LCCU New Bern

ADDENDUM

3

RE: LCCU - New Bern: RFI 8.3.2022

2 ELEVATION TYPE A.1 - LOUVER WALL
A602 SCALE: 1/4" = 1'-0"

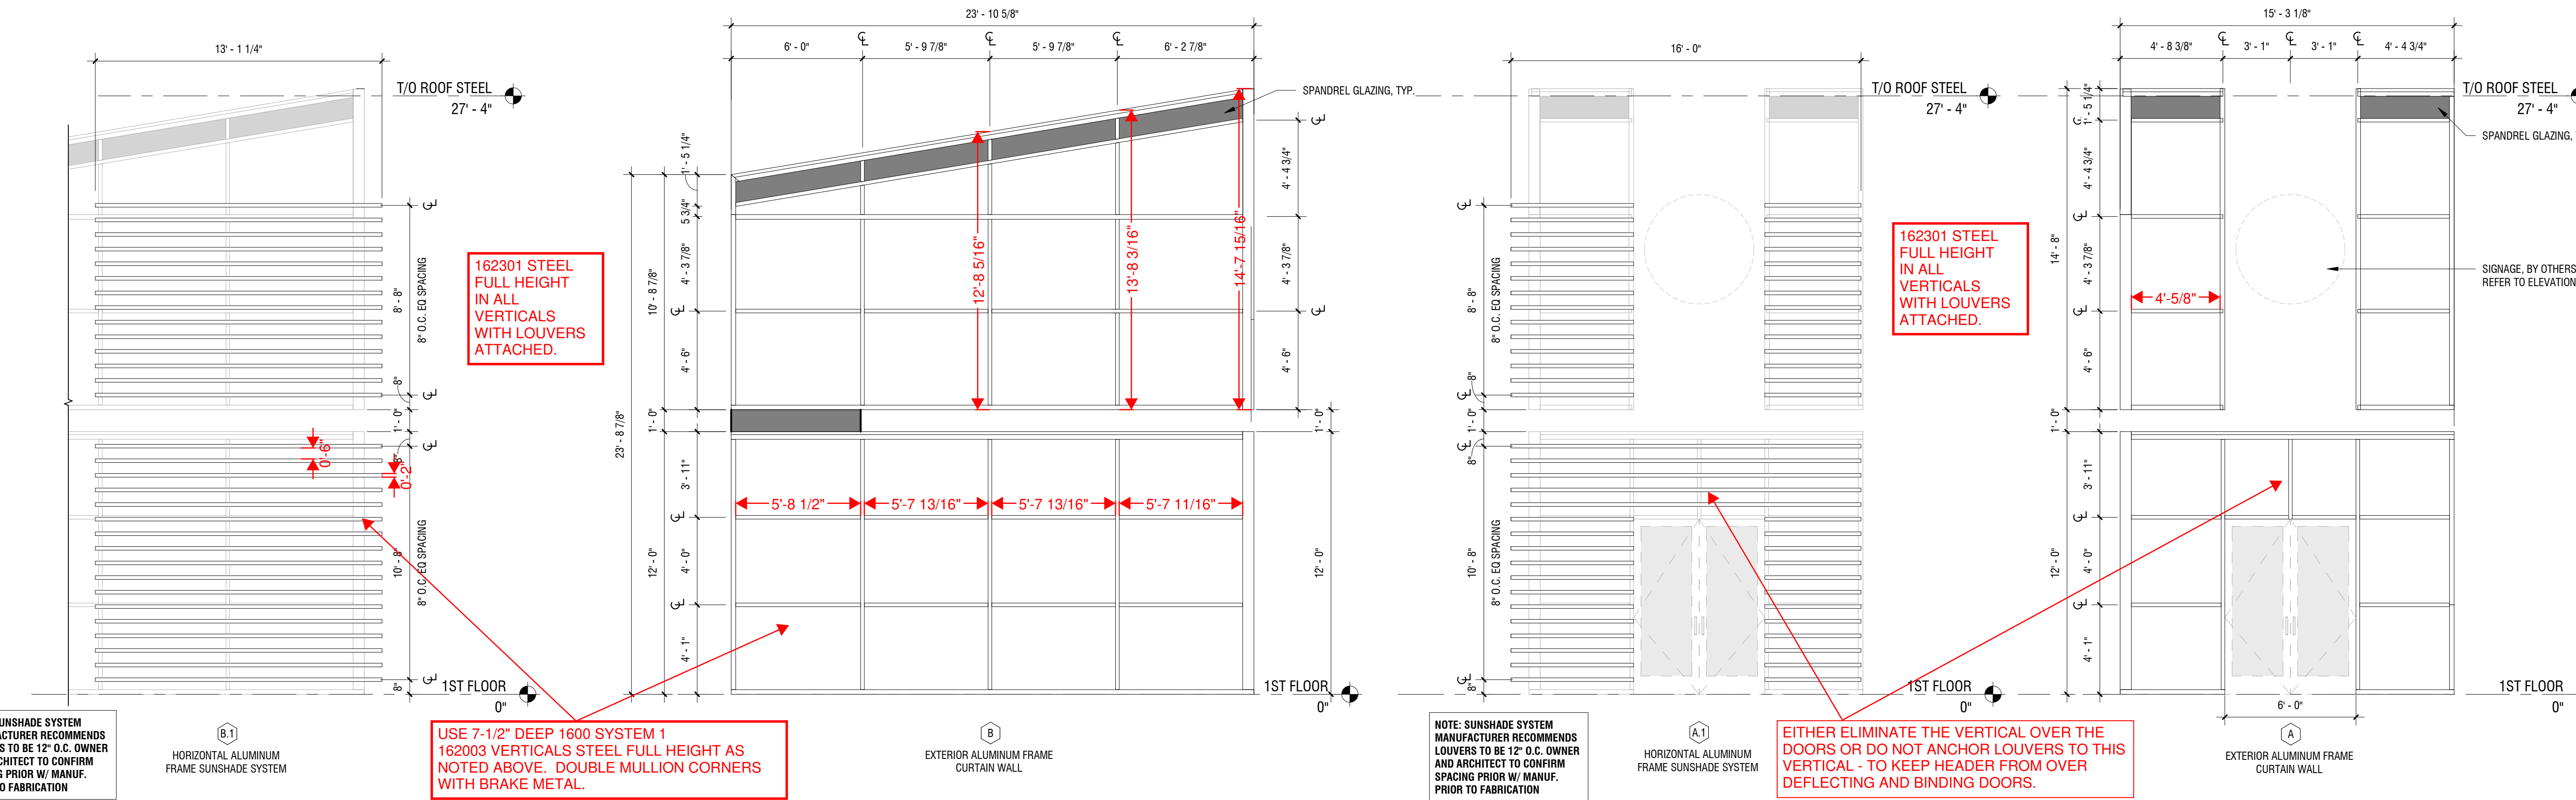
- a. Preliminary detail provided by Kawneer + Longboard
11. The louvers or Longboard shades are spaced 8" o.c. vertically. There is a note referring to 12" o.c. spacing on elevation 2/A602. Where does the 12" o.c. refer to?

REVIEW BY: TIM WASHBURN 7/22/22
REVIEWED ELEVATIONS A, A.1, B, AND B.1
WL ZONE 4 = +19 PSF / 20 PSF
WL ZONE 5 = +19 PSF / 25 PSF

NOTE: SUNSHADE SYSTEM MANUFACTURER RECOMMENDS LOUVERS TO BE 12" O.C. OWNER AND ARCHITECT TO CONFIRM SPACING PRIOR W/ MANUF. PRIOR TO FABRICATION

USE 7-1/2" DEEP 1600 SYSTEM 1 162003 VERTICALS STEEL FULL HEIGHT AS NOTED ABOVE. DOUBLE MULLION CORNERS WITH BRAKE METAL.

162301 STEEL FULL HEIGHT IN ALL VERTICALS WITH LOUVERS ATTACHED.

EITHER ELIMINATE THE VERTICAL OVER THE DOORS OR DO NOT ANCHOR LOUVERS TO THIS VERTICAL - TO KEEP HEADER FROM OVER DEFLECTING AND BINDING DOORS.

- a. Disregard 12" o.c. note
12. Who is responsible for window elevation type C (teller window) if glaziers are responsible for this and not the owner, we will need a full spec section along with a basis of design

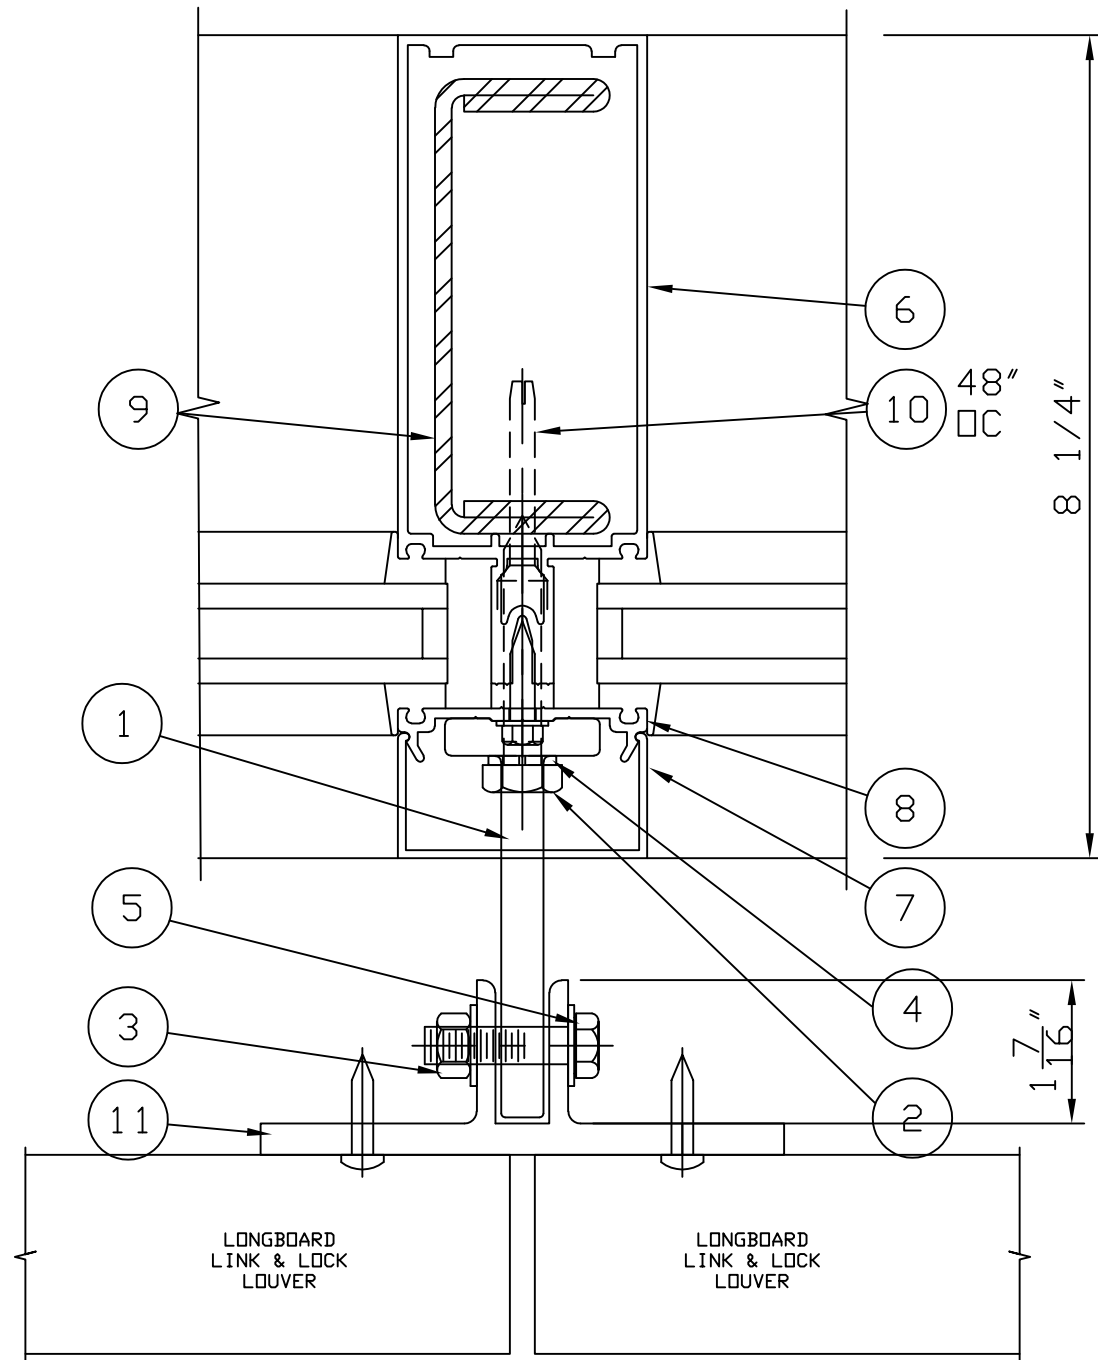
- a. Disregard
10. Are there any details for the attachment of the longboard Link & Lock sunshade system shown in the elevations on sheet A602. Section 7/A503 shows the louver in mid-air. If the louver slates are attached to the aluminum storefront material the storefront manufacturer may have issues with us attaching to their system when it comes to finish warranties, weather tightness and design loads. A separate framing system independent of the storefront system may be needed for the louvers
